SAN FRANCISCO PLANNING DEPARTMENT

Addendum to Environmental Impact Report

Addendum Date: December 11, 2013
Case No.: 2007.0946E
Project Title: Candlestick Point-Hunters Point Shipyard Phase II
EIR: 2007.0946E, certified June 3, 2010
Project Sponsor: CP Development Co., LP
Lead Agency: San Francisco Planning Department/Office of Community Investment and Infrastructure
Staff Contact: Chris Kern – (415) 575-9037
chris.kern@sfgov.org

FIGURE 1 – NON-STADIUM VARIANT 2A 2010 PHASING SCHEDULE^a

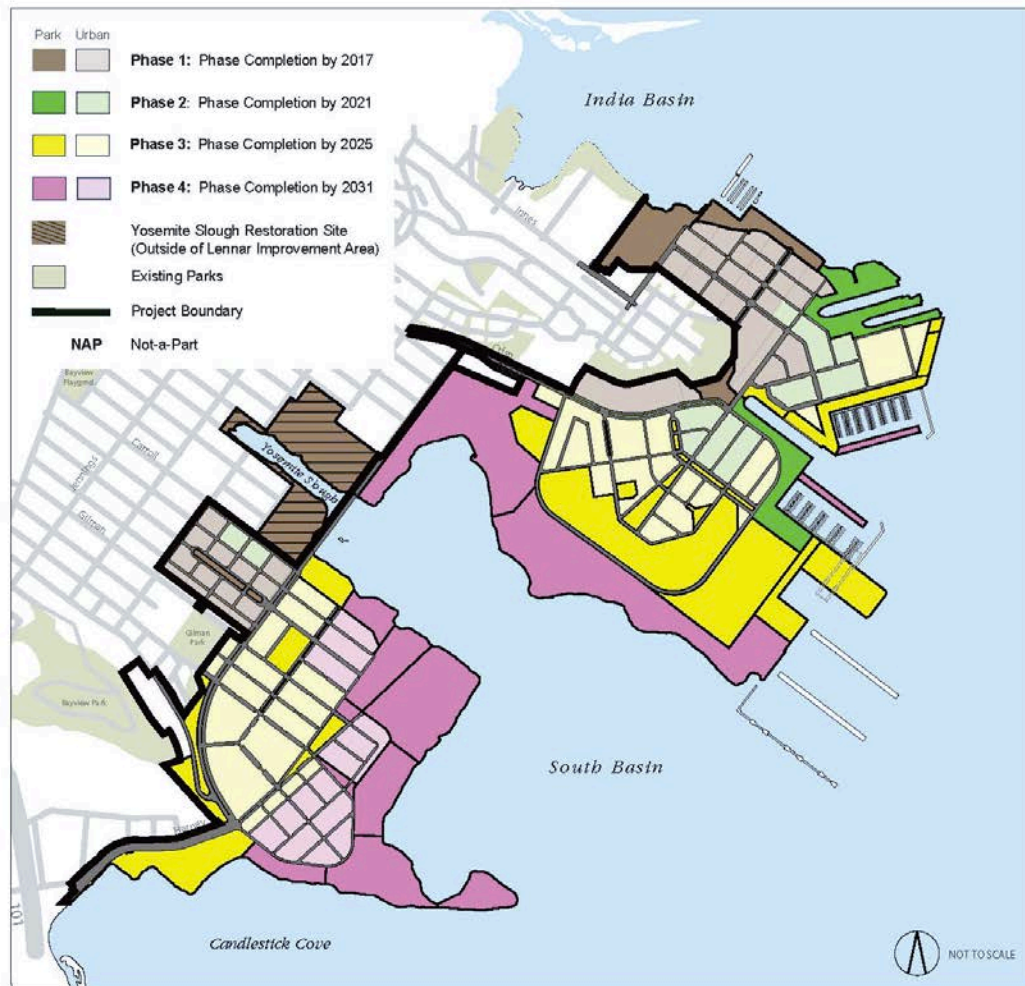
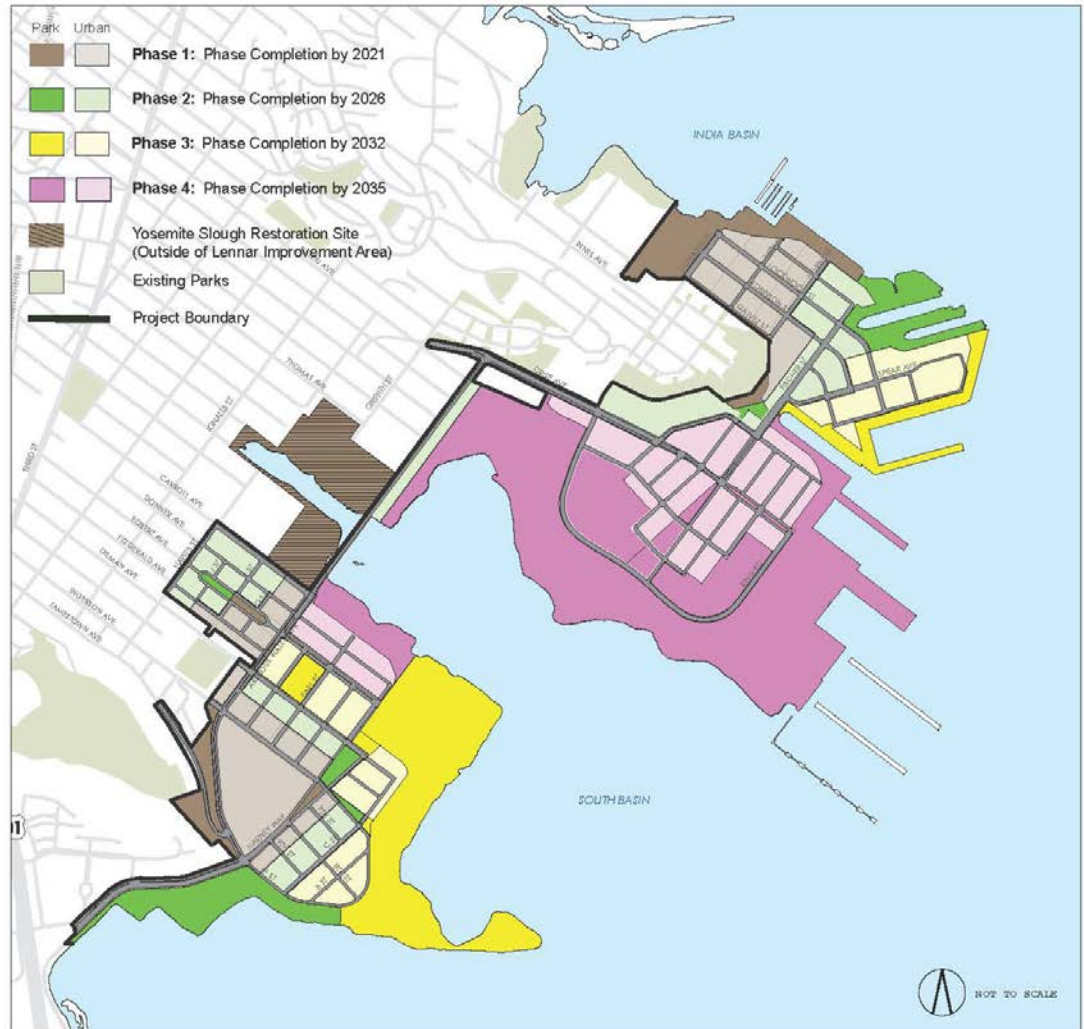
- Demolition of Candlestick Park stadium and construction of the Candlestick Point Regional Retail Center in Major Phase 1 instead of Major Phase 3 as shown in the 2010 Project Phasing Schedule.
- Development of all of the research and development blocks on Parcel C in HPS Phase II in Major Phase 3 instead of splitting this development between Major Phase 2 and 3 as shown in the 2010 Project Phasing Schedule.
- Development of all improvements in the HPS Phase II South area in Major Phase 4 instead of splitting this development among Major Phases 2, 3, and 4 as shown in the 2010 Project Phasing Schedule.

Tables 1-5 and **Figures 1 and 2** compare the 2010 Project Phasing Schedule with the proposed 2013 Project Phasing Schedule.

Figure 3

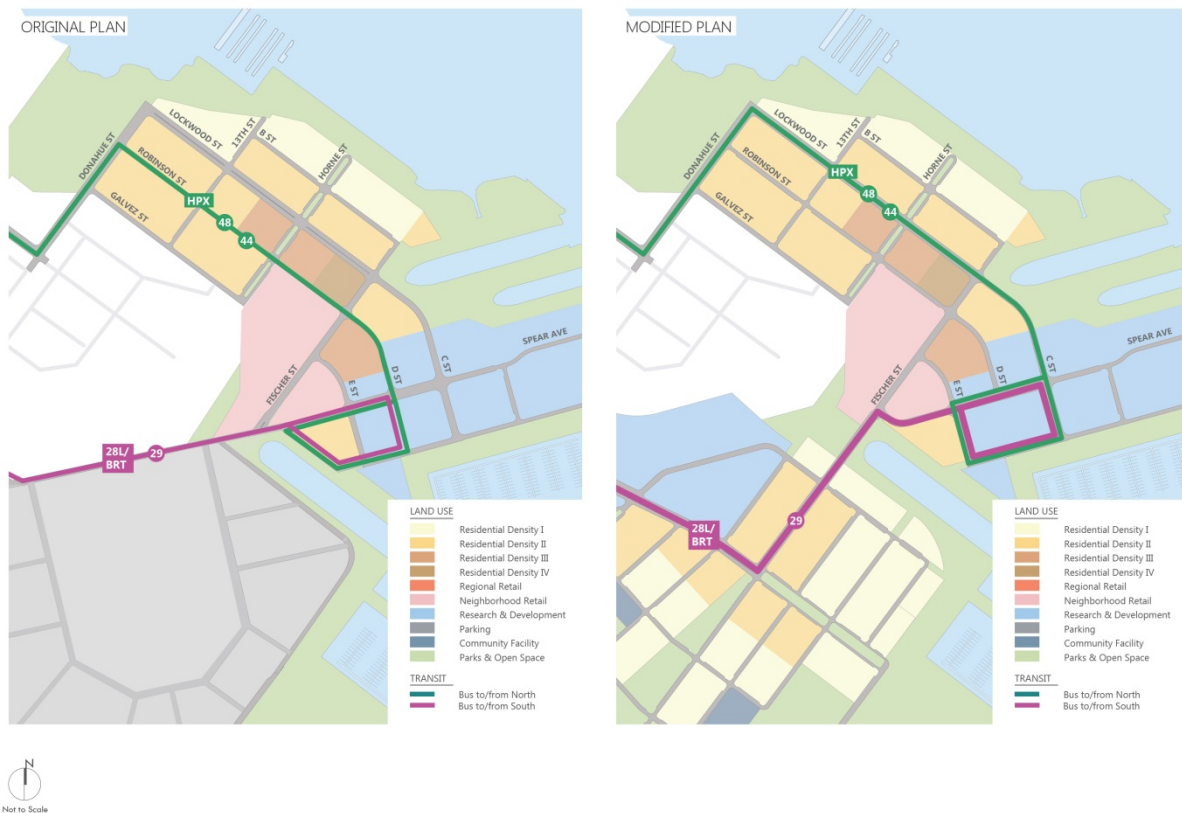
Figure 3 below illustrates the proposed change to the 29 Sunset routing within Candlestick Point. The Project as described in the FEIR called for the 29 Sunset to circulate within the Candlestick Point retail center. Under the proposed project modifications, the 29 Sunset would continue to serve the front of the retail center along Ingerson Avenue, but instead of circulating within the retail center, the route would circulate around the development blocks to the north, so that the 29 Sunset would provide more direct service to the high-density residential buildings proposed near the intersection of Gilman Avenue and Harney Way. This minor routing change is anticipated to increase the Project's transit mode share by bringing transit service closer to more residential units while continuing to provide direct "front-door" service to the retail center.

FIGURE 5 – COMPARISON OF TRANSIT SERVICE RELATIVE TO DEMAND DURING PROJECT BUILD OUT AT CANDLESTICK POINT

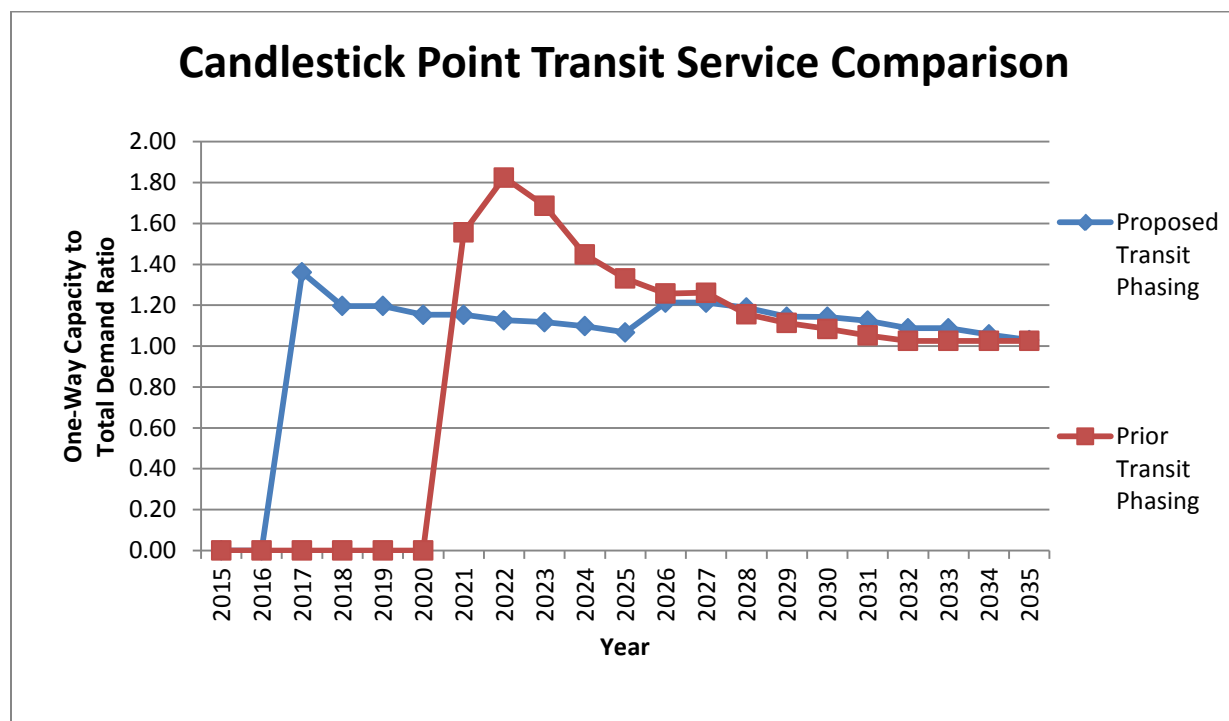
Figure 5 illustrates that with the revised development schedule and revised transit phasing, the level of transit service relative to demand would remain similar to or greater than the identified in the FEIR at build out. Thus, transit would remain an attractive option for travelers in the area.

FIGURE 6 – COMPARISON OF TRANSIT SERVICE RELATIVE TO DEMAND DURING PROJECT BUILD OUT AT HUNTERS POINT SHIPYARD

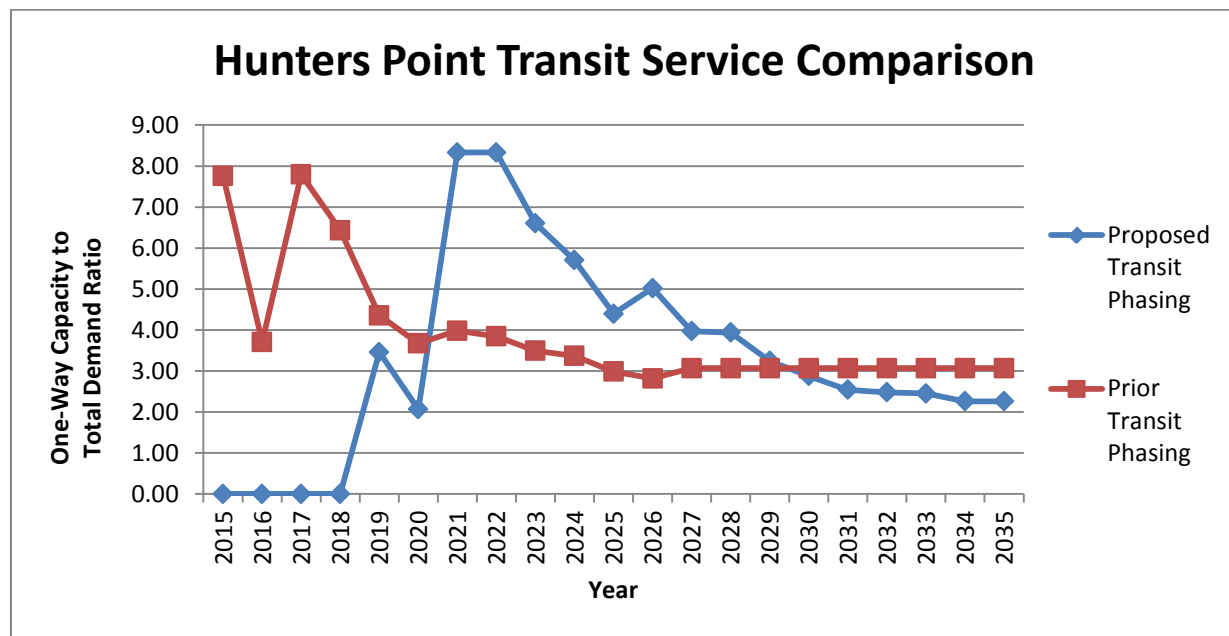
Figure 6 illustrates that once substantial development begins to occur in Hunters Point, the level of transit service relative to demand would exceed what was anticipated in the FEIR, based on the original development and transit implementation phasing until approximately year 2030. After that, the modified project appears to provide less transit service relative to demand than the original project is because the “original” project shown is the stadium alternative and the modified alternative is the Non-Stadium Alternative Variant 2A, which provides the same level of transit service with slightly higher demand than the Stadium Alternative. As a result, transit service would remain an equally attractive option in Hunters Point under the modified project development and transit phasing as was evaluated in the FEIR.

Figure 7

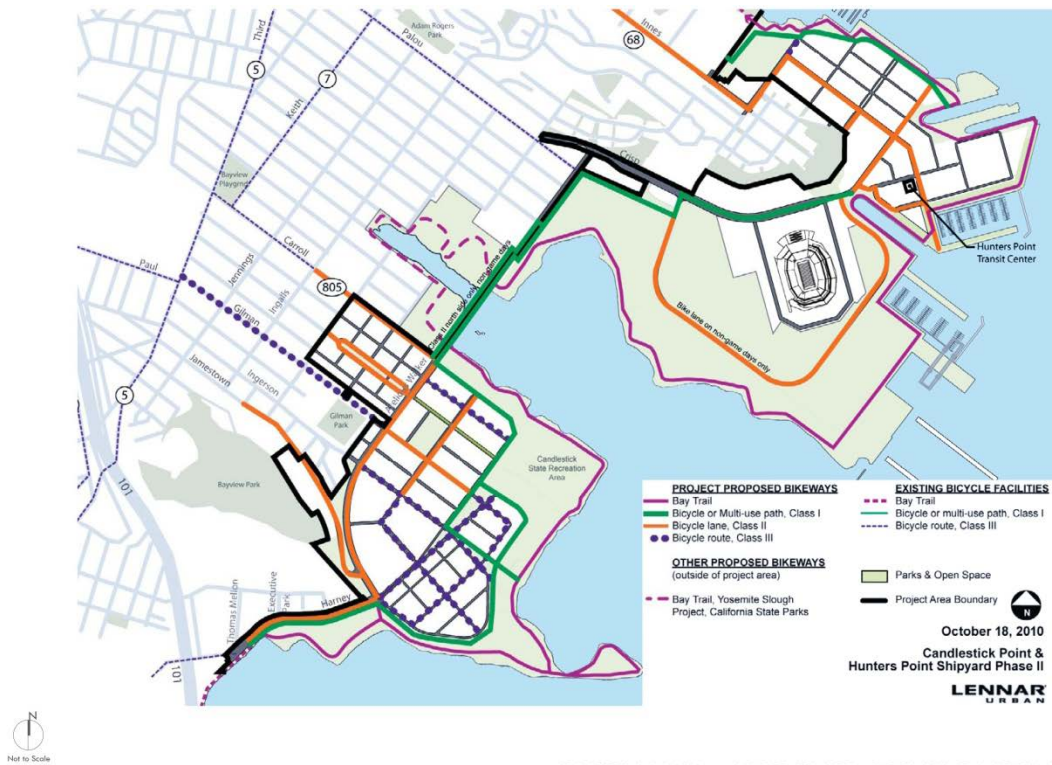
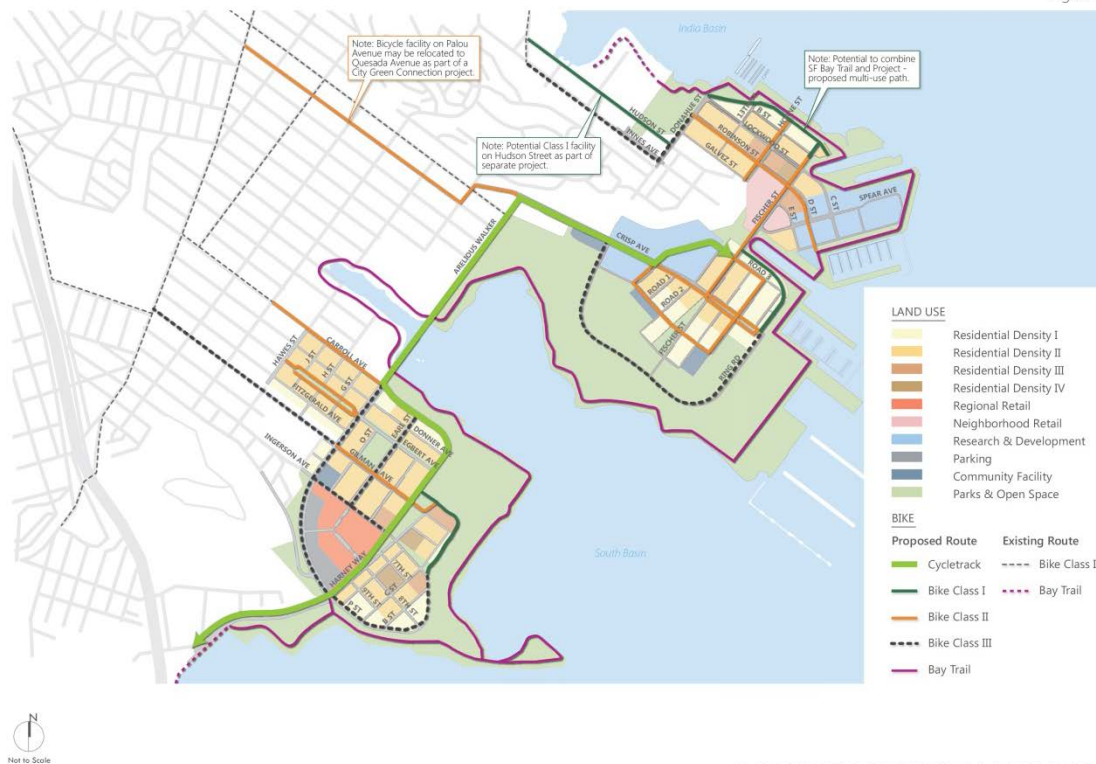
As shown in **Figures 7 and 8**, the modified Project includes refinements to the proposed bicycle network. The changes include replacing the Class II facilities on Arelious Walker Drive with a new, separated, two-way Class I bicycle facility that travels through the heart of the project, and more directly connects the CP and HP project sites. The original bicycle network included Class II facilities on Arelious Walker Drive that connected from the Yosemite Slough Bridge to Harney Way, essentially the only route connecting one end of the Candlestick Point site to the other. The original project also included Class II facilities on Harney Way adjacent to the retail center and the wedge park north of Ingerson Avenue. But, between Ingerson Avenue and Arelious Walker Drive, only Class III facilities were provided, which meant that no dedicated facilities would be provided through the retail core of the project.

The proposed refinements to the bicycle network would replace the Class II facilities on Arelious Walker with a new Class I two-way cycle track that travels through the wedge park and the retail center of the Candlestick Point site. The cycle track would be fully separated from auto traffic, travel along a route with fewer intersection conflicts, and would provide a flatter topographic route. As a result, the proposed cycle track is expected to be more desirable to both commuters and recreational cyclists. The cycle track would continue north through the Hunters Point Shipyard site to the Hunters Point transit center and south along Harney Way toward US 101, where ultimately it could be connected to the Bay Trail and/or other regional facilities. When fully-constructed, the new cycle track facility would provide a dedicated, two-way, Class I facility connecting the Hunters Point Shipyard and Candlestick Point sites to each other and to regional bicycle and transit facilities. Arelious Walker Drive would retain a Class III designation.
